Selwyn District Council

**RE: RC245775 - Darfield Solar and Energy Storage Ltd Additional Response to the Request for Further Information, Landscaping Matters**

Mitchell Daysh Limited

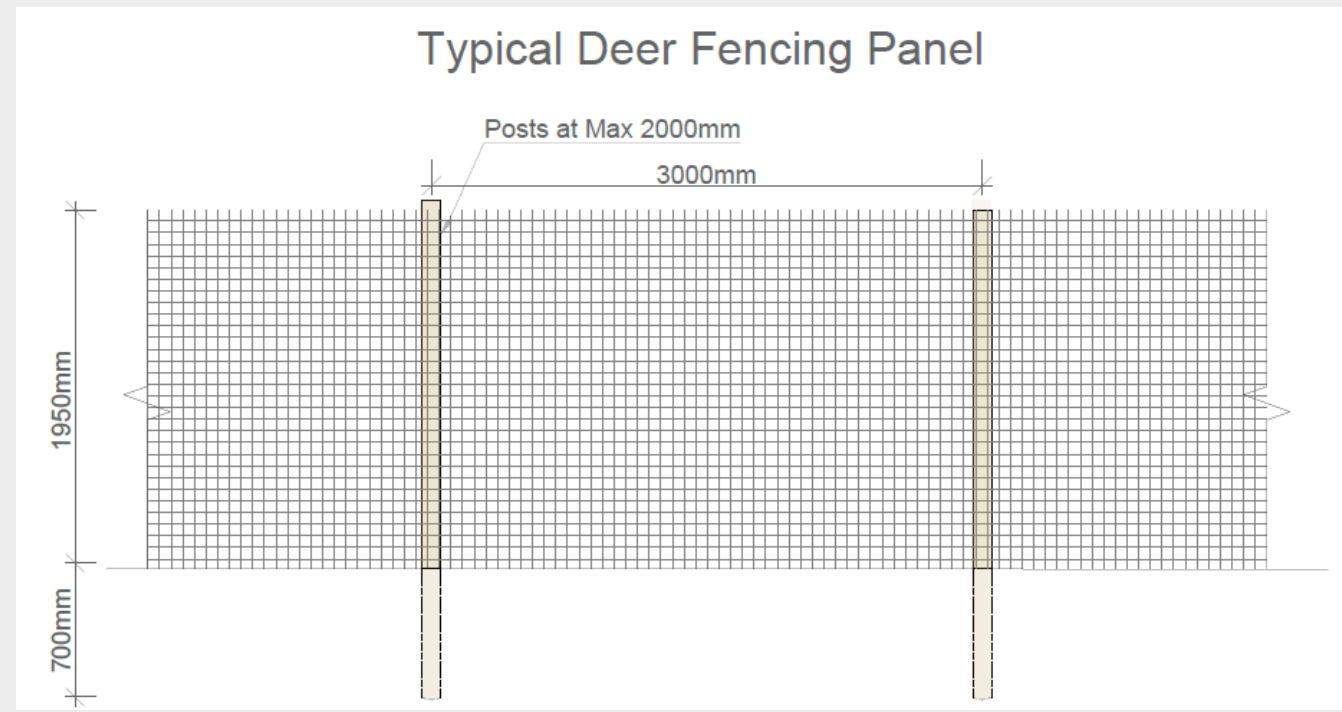
8. Please provide a further description and associated example image of the fencing being this will be visible from the surrounding areas i.e. what is the type and anticipated appearance of security fencing (itemised at deer-style security fence at 2.4m high).

The proposed security fencing would be comparable to that shown in the below diagram, although to a maximum height of 2.4m. This indicative diagram has been borrowed from a comparable development within the rohe of Waikato District Council, which obtained approval from an EPA panel on 22 December 2023. The second image is of an example of the style of deer fencing we are intending to utilise.

It is noted that the visual simulations all include deer fence of the proposed height within the generated images.
